Permit Application Review

Applicant:	Michael Bauer
Consultant:	Vladimir Sivriver; Engineering Design and Services
Project:	Building Addition and Site Improvements – Bauer's Service Center
Location:	13118 Excelsior Boulevard: Minnetonka
Rule(s):	4 and 5
Reviewer(s):	BCO

PROPOSED DRAINAGE AREAS

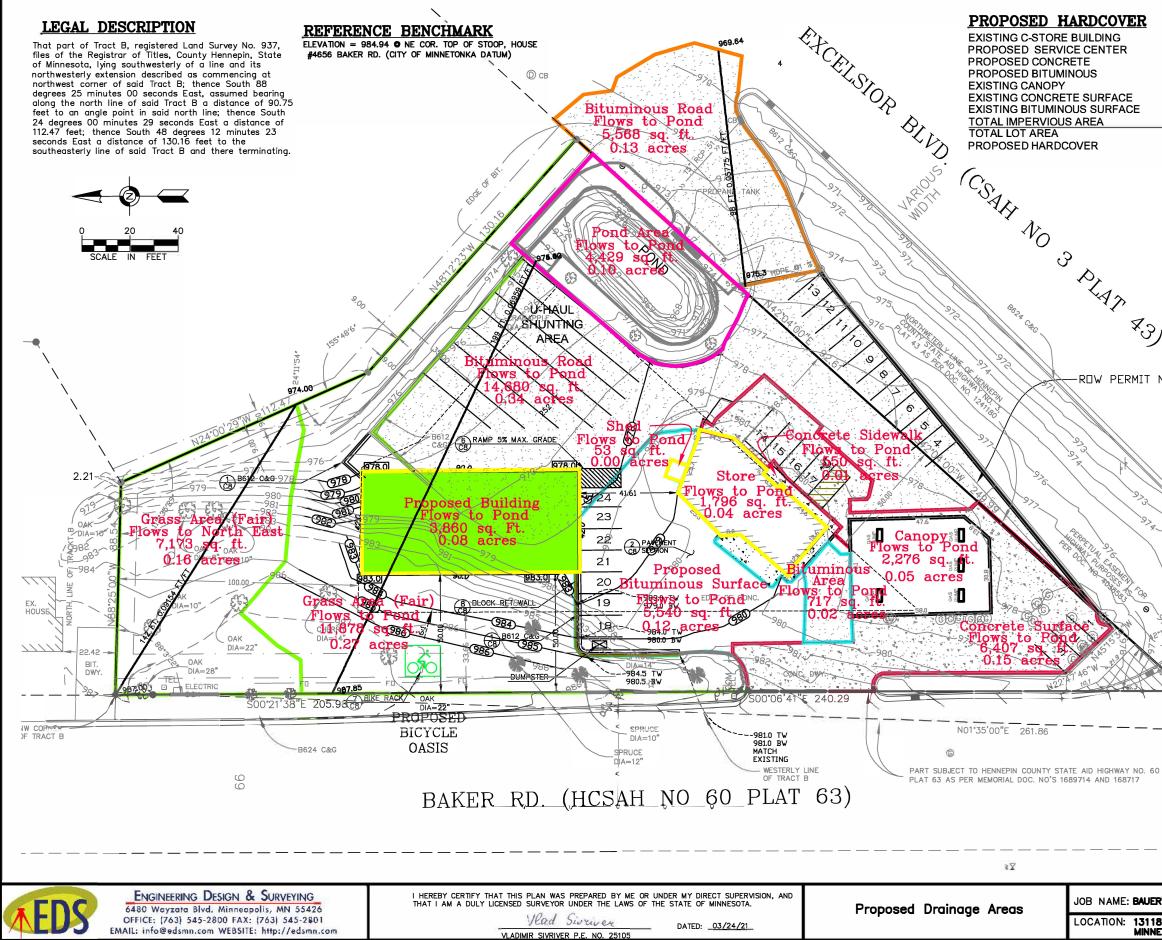
The applicant's submittal assumed stormwater management for the entire proposed site impervious area, 32,920 square feet, used for the stormwater analysis.

An infiltration volume of 3,017 cubic feet is required from the proposed 32,920 square feet of site impervious area, Rule 4.3.1a. The Basin provides a volume of 3,308 cubic feet (3,017 cubic feet required) with an area of 1,661 square feet (943 square feet required) at a depth of 3.2 feet. This is the maximum depth of inundation allowable for the retention volume to be drawn down within 48 hours using an infiltration rate of 0.8 inches/hour. Rule 4.3.1a is met.
